## SERVICE LETTER No. L 135

**MODEL AFFECTED:** Z 242 L aircraft, S/N: 0852, 0853, 0854, 0855

**SUBJECT:** Corrective action of the aircraft manufacturer to prevent damage to the lower engine cover Drwg. No. Z242.6510-01.00

*Fig. 1 Illustration of exhaust system with modified exhaust silencer I*

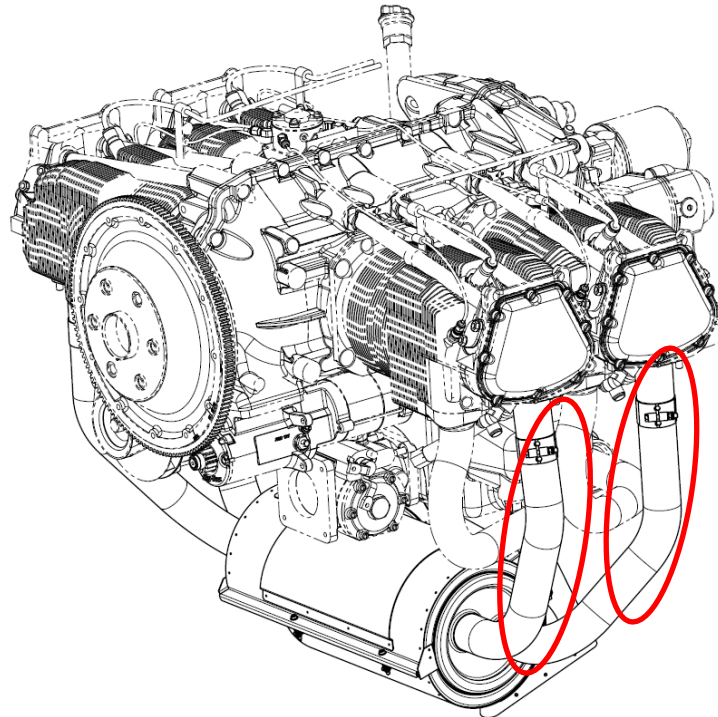
Based on operational experience, when the left exhaust tube is located close to the composite lower engine cover, the possibility of thermal influence of the lower engine cover through this tube is eliminated following corrective action.

This corrective action consists in shortening the two tubes of the exhaust silencer Drwg. No. L242.6671-01.00G by 10 mm only on the left side of the exhaust at the point of division into the sleeve.

This increases the free space between the exhaust and the lower engine cover only on the left side.

The modification cannot be performed on right side of the exhaust, because on the right side there would be a collision with other engine parts.

The modified exhaust silencer has the designation Drwg. No. 990-527-00 and the total assembly of the modified exhaust silencer I is marked under Drwg. No. L242.6671E\_UPR.

**PROCEDURES:**             Based on the operator's request, the aircraft manufacturer will supply a modified exhaust silencer with the designation Drwg. No. 990-527-00.  
                                  The aircraft operator will install a modified exhaust silencer.
